## Surfrider Foundation

December 16, 2008

## Additional Comments on Matilija Dam Final Design – Slurry Disposal

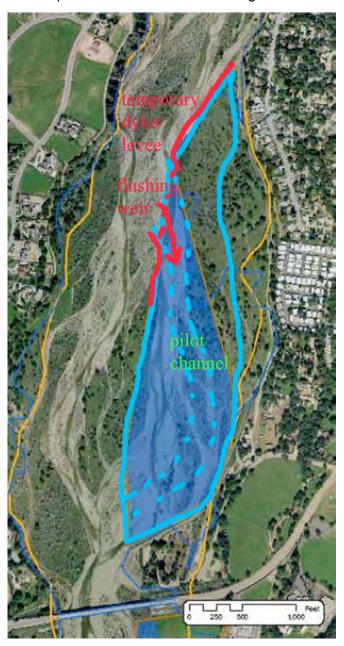
**BRDA 1** would provide *temporary storage of 750 AF of fine sediments*, intended to be completely transported downstream following a series of flood events. This is accomplished by managing a pilot channel that follows the alignment of the existing river side-channel. This pilot channel will direct high flows from the mainstem channel through the disposal area to initiate and actively erode the sediments. This is controlled with a temporary levee (or containment dyke) that includes a 'flushing weir' at the upstream end of the pilot channel.

The footprint outlined in blue in this figure includes expansion of the disposal area onto

the floodplain terrace to the east of the active channel. This would provide greater insurance that flows would not enter behind the disposal area and threaten downstream infrastructure. This area will also provide a staging area and additional capacity to account for the pilot channel, which would necessarily be an area of lower fill depth.

Adaptive management of this area would include monitoring the containment dyke and erosion to ensure release of fine sediments downstream occurs predetermined flow events. The weir entry is designed to direct flows into the pilot channel during such events to facilitate removal of stored sediments. In this manner a large flood event may effectively remove a large portion of the temporary sediments (highlighted in blue.) In the dry season following such an event the remaining sediment could be redistributed within this erosion zone in preparation for the next flood. Eventually this area would return to floodplain with evidence of the slurry activities.

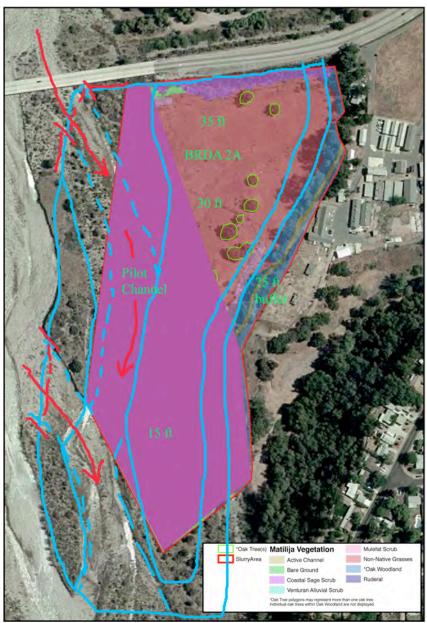
The BRDA 2 disposal area may store 600 AF of sediment (BRDA 2 with BRDA 2A superimposed.) BRDA 2A is a 15-acre sub-area in which the total deposition would average 30 ft deep. The erodable area (pink) includes a pilot channel designed in the same manner as BRDA 1. The fill is deepest adjacent to Baldwin Rd, which could be used as a containment dyke. The east edge of the disposal area will taper down to leave a 75 ft buffer/channel from the toe of the bluff to accommodate existing flows and maintain the mature sycamore and oak trees. The disposal area is expanded slightly to the west and south to provide additional capacity to account for the buffer zone and pilot channel.

**Adaptive management** would be used to optimize the erosion of temporary storage areas as described for BRDA1. The upland terrace would be revegetated, but the pilot channel and erosion zone would require minimal restoration. *In the future, the BRDA 2A area may be all that remains as a permanent feature of the landscape*, so full restoration efforts need only be focused on this 15-acre area.
